Addendum No: 9
Date: February 15, 2024
Owner: Northern Health
Stantec # 144320228

This addendum is to be read with and constitutes part of the tender document.

UHNBC (University Hospital of Northern BC) - Pharmacy upgrade

Title
**LEVEL 0 - EXISTING AND DEMOLITION
CEILING PLAN**

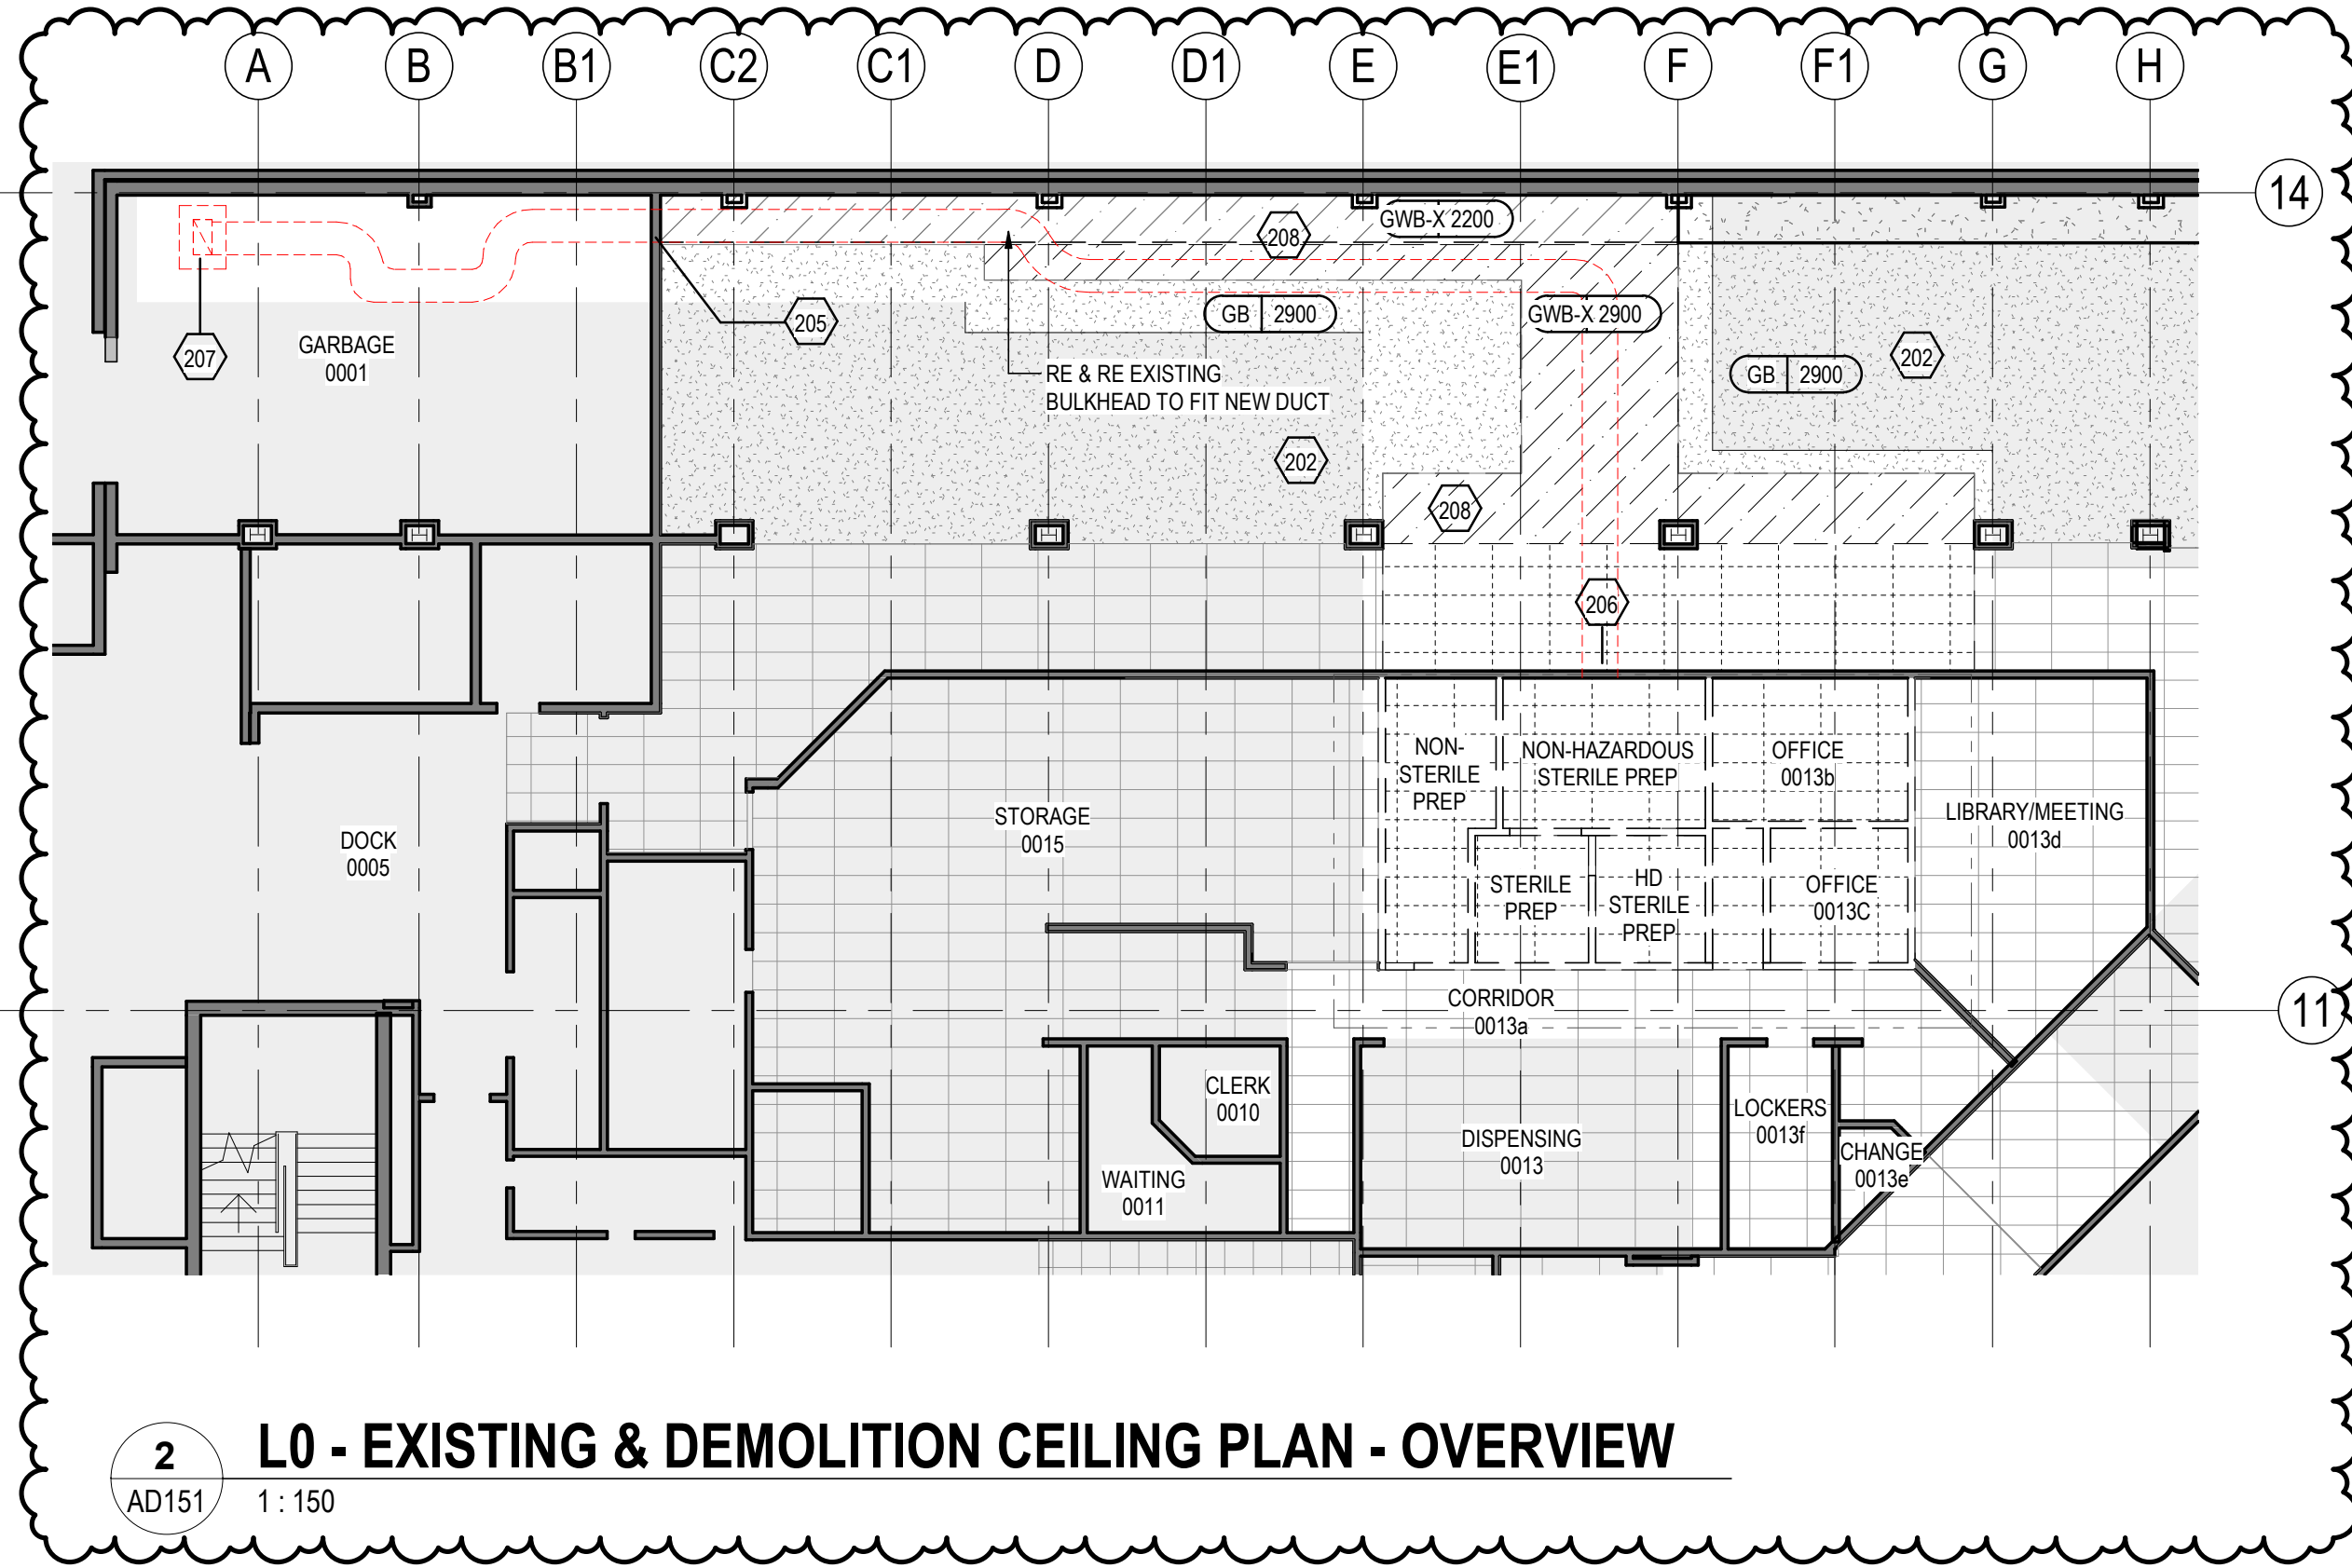
AD151- LEVEL 0 – EXISTING & DEMOLITION CEILING PLAN – OVERVIEW

Drawing 2 updated to show better mechanical route for new duct.
